# January 2, 2003, 9:00 a.m.

### **Technical Advisory Committee**

1. Fred Orr and Kevin Geraghty presented Pelham Manor, Section 1, Phase 1 & 2, Lots 3-5, 8-14, 16-20, 30-33, 35-41, 46-48, 69-74, 76-97, Williams Road, Preliminary Plat, Morris & Ritchie Associates, Inc., Second District.

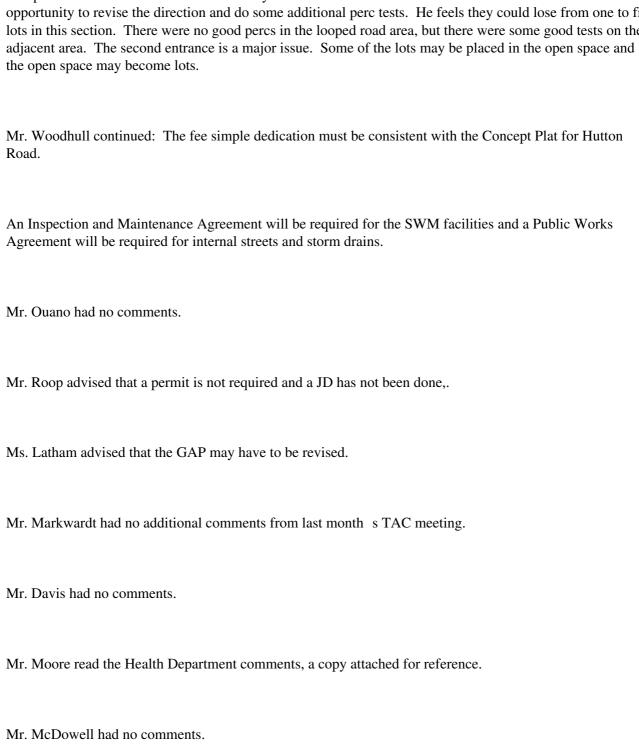
Mr. Orr stated that this is Section 1, Phase 1 of 2, that was before the TAC last month, bearing revisions based on the inconsistencies in the perc data table, as well as graphic corrections to the perc test locations shown. All perc testing is now shown on this plat. There will be changes to the plat based on additional testing. The Preliminary Forest Conservation Plan has been approved and the GAP has been updated, however it will have to be updated again.

Mr. Woodhull stated a Stormwater Management (SWM) Plan, Street and Storm Drain Plan, and a Mass and Final Grading Plan must be approved by the CCDPW prior to submittal for Final Plat approval. The Final Plat must include the standard note recognizing the applicability of the Lot Grading Plans. ( A lot grading plan has been approved by the CCDPW for the construction shown hereon. A site construction as-built shall be submitted to the CCDPW prior to use and/or occupancy of any of the sites shown hereon. ).
